2425 – 2427 Bayview Avenue – Official Plan Amendment, Zoning Amendment and Site Plan Control Applications – Request for Direction Report

Date:	May 28, 2015
To:	North York Community Council
From:	Director, Community Planning, North York District
Wards:	Ward 25 – Don Valley West
Reference Number:	14 209080 NNY 25 OZ & 14 209092 NNY 25 SA

Attachment 1: Site Plan

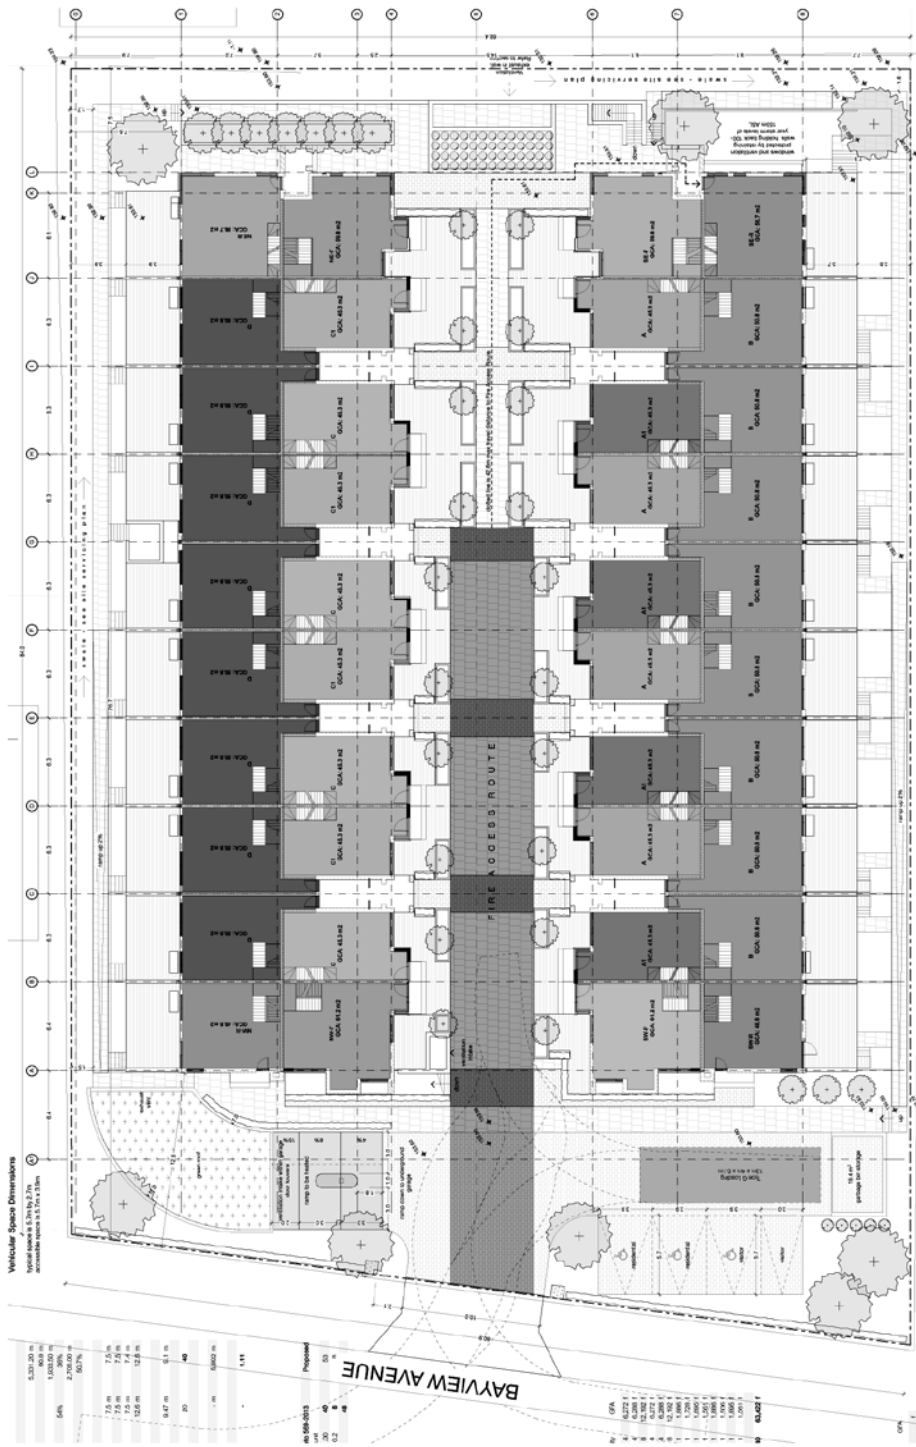
The proposed development does not respect and reinforce the character of the neighbourhood as required by the OP nor does it meet the Built Form policies of the Plan. Bayview Avenue is characterized by large, landscaped front yards with buildings fronting Bayview Avenue. The proposed townhouses front onto a private pedestrian courtyard and the front yard of the site is dominated by parking, servicing and a driveway leaving little opportunity for landscaping. The proposal is not consistent with the policies of the Official Plan and should be refused.

The proposed townhouses do not achieve the General Principles, discussed earlier in this report, which have emerged from the study. The relationship between Bayview Avenue and the units is not appropriate as they neither front onto Bayview Avenue nor do they support the street. With the exception of two units, the unit entrances face the central courtyard rather than Bayview Avenue. In addition to not framing the street, the units are also separated from Bayview Avenue by a driveway, loading area and parking spaces. These spaces encompass the front yard reducing the opportunities for landscaping, while the character of Bayview Avenue is of large, landscaped front yards.

Bayview Avenue is also characterized by large, landscaped front yards which are primarily required to be soft landscaping under By-law 7625. The front yard of the proposed townhouses would largely be occupied by parking, loading and a driveway rather than providing soft landscaping. This does not respect and reinforce the existing physical character as required in the Official Plan.

The applicant has also appealed the application for Site Plan Control. While staff have concerns with the proposed amendments to the Official Plan and zoning by-law, there are also concerns with Site Plan matters. The organization of the site along Bayview Avenue and the amount of landscaping in the front yard is insufficient and should be increased to better reflect the character of Bayview Avenue. In order to achieve this, the loading space and visitor parking should be removed from the front yard. In addition to increasing the landscaping, this also allows for direct pedestrian connections between the landscaped courtyard and the Bayview Avenue public sidewalk. The grading of the site and response to the streetscape also remain concerns of staff.
